**To:** Lara Fiscalini  
**From:** Civil Engineering unit; Mark Pisani  
**Date:** 3 June 2020  
**Subject:** Application No: PLN19/0931  
 Description: AMCOR; Precinct 5  
 Site Address: 1 Latrobe Avenue, Alphington

I refer to the above Planning Application received on 3 April 2020 in relation to the proposed development at 1 Latrobe Avenue, Alphington. Council's Civil Engineering unit provides the following information:

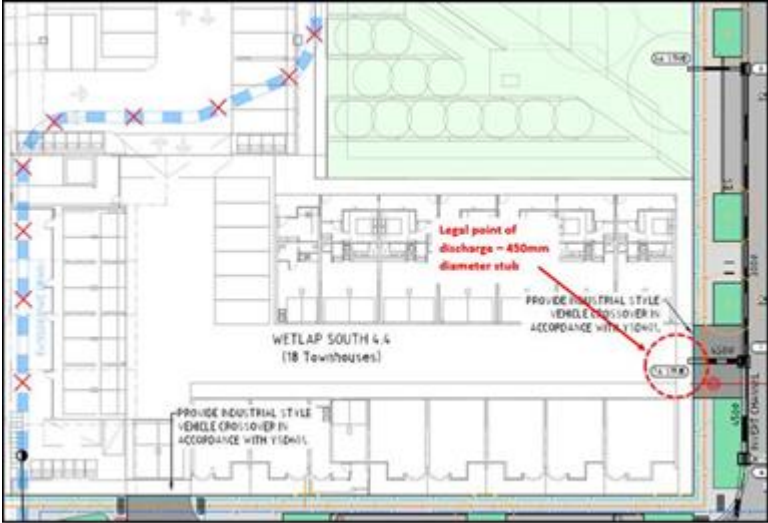
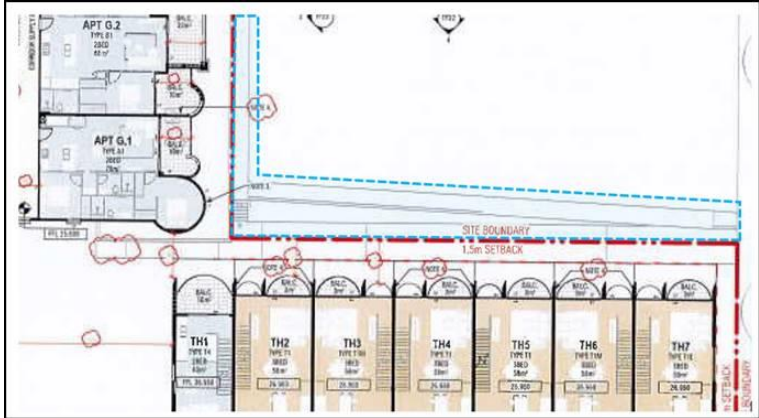
Details of Area outside of Site Boundary	<p>The applicant is to provide further detail of what is shown in the outlined blue area in Figure 2. The area is located within Council owned area outside the site boundary. There should be no private property infrastructure positioned within publicly owned land.</p>  <p>Figure 2 - Paper Square park area</p>
